Access Compliance Report

Public Rights-of-Way

(Curb Ramps)

Intersection ID: 44911	Main Street: FOX_POINT_DR	Cross Street: SPRINGHAVEN_DR	Location:	E
ADA ID: 47DB6FC561E6	Ramp Type: PerpDiag	Initial Pass/Fail: Fail	Overall Compliance: No	Severity Score: 25

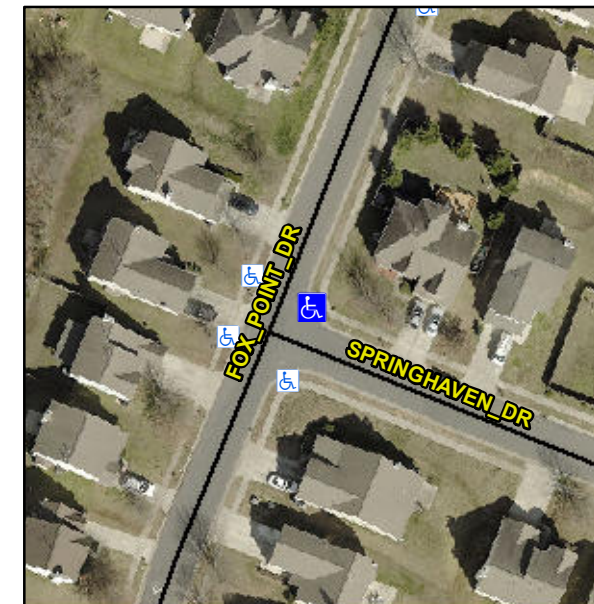
Not Found, R304.5.1, R304.5.3, R302.7

Compliance	Description	Data	Compliance	Description	Data
N/A	Ramp Length (in)	48.0	Yes	Ramp Slope (%)	7.1
No	Ramp Width (in)	40.0	No	Ramp XSlope (%)	4.7
N/A	Flare Type LT	N/A	N/A	Flare Type RT	N/A
N/A	Flare Slope LT (%)	N/A	N/A	Flare Slope RT (%)	N/A
N/A	Flare Traversable LT?	N/A	N/A	Flare Traversable RT?	N/A
N/A	Landing Length (in)	N/A	N/A	DWS Provided?	N/A
N/A	Landing Width (in)	N/A	N/A	DWS Contrast?	N/A
N/A	Landing Slope (%)	N/A	N/A	DWS Length (in)	N/A
N/A	Landing X Slope (%)	N/A	N/A	DWS Full Width?	N/A
N/A	Landing Curb? (Y/N)	N/A	N/A	DWS Offset (in)	N/A
N/A	Shared Landing?	N/A			
N/A	Gutter Ponding?	N/A	N/A	Gutter Slope (%)	N/A
N/A	Gutter Lip Ht (in)	N/A	N/A	Gutter X Slope (%)	N/A
N/A	Painted X Walk1?	No	N/A	Painted X Walk2?	No
	X Walk 1 Direction	To NW		X Walk 2 Direction	To SW
N/A	X Walk 1 Width (in)	N/A	N/A	X Walk 2 Width (in)	N/A
	X Walk 1 Slope (%)	8.8		X Walk 2 Slope (%)	4.3
	X Walk 1 X Slope (%)	2.3		X Walk 2 X Slope (%)	7.4

Remove & Replace Curb Ramp With Two New Directional Ramps or Equivalent.
